Re: Shell Station Addition – Eisenhower and Saline-Ann Arbor Road

On behalf of Cranbrook Village Limited Partnership (“Cranbrook”) I provide the following response (shown in CAPS RED) to Mr. Todd Quatro’s correspondence of June 18, 2019 regarding the additional building and other changes proposed at the Shell Gas Station site located at 2679 Saline-Ann Arbor Road (“Proposed Project”).

## SHELL STATION ADDITION - SUMMARY OF COMMENTS ON SITE PLAN REV. 7

SHEET NO.: A5

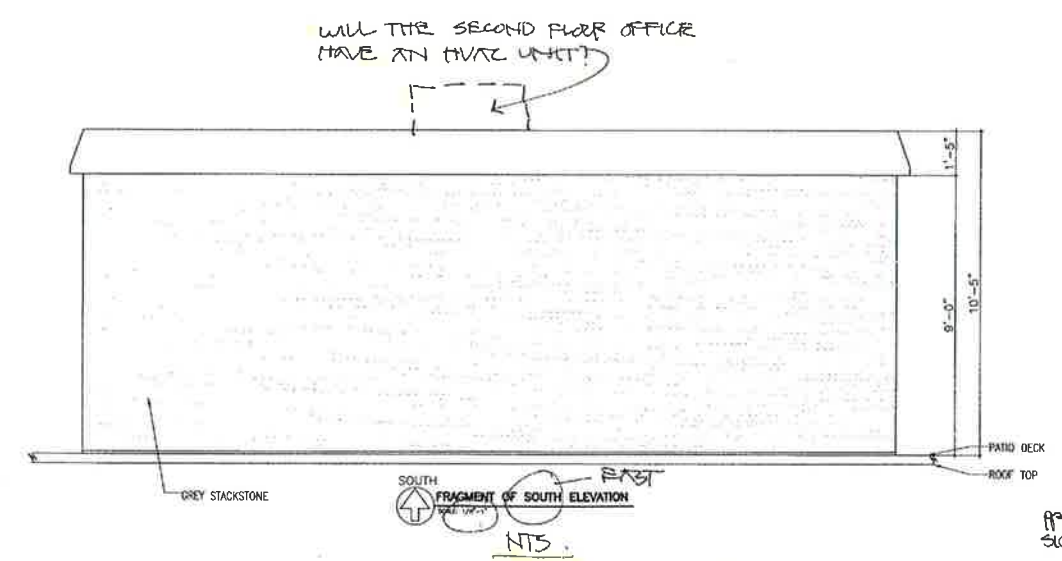
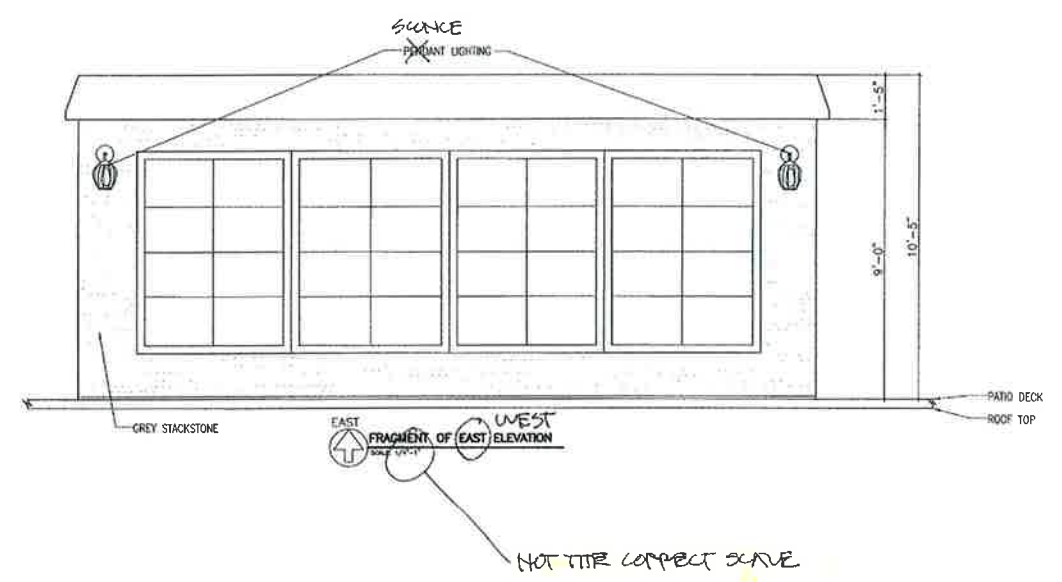
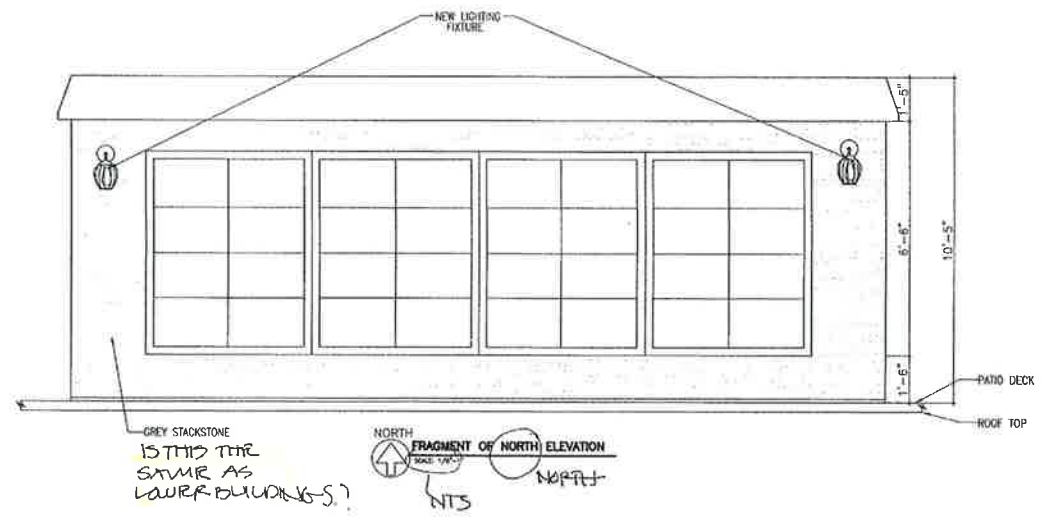
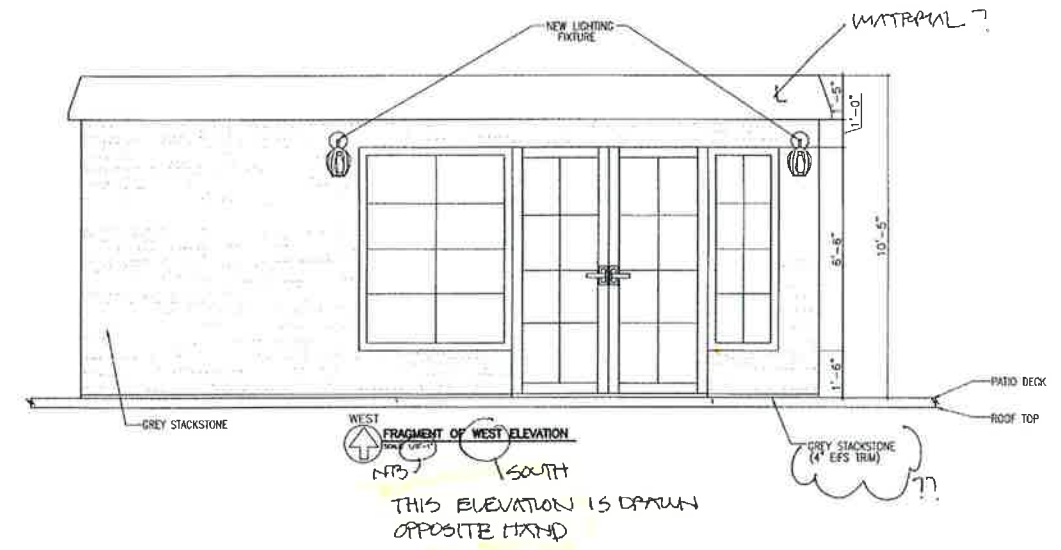
The elevations do not match the plans.

GENERAL NOTE:  
 THE ELEVATIONS ARE OUT OF SCALE  
 IN THE HORIZONTAL PLANE.
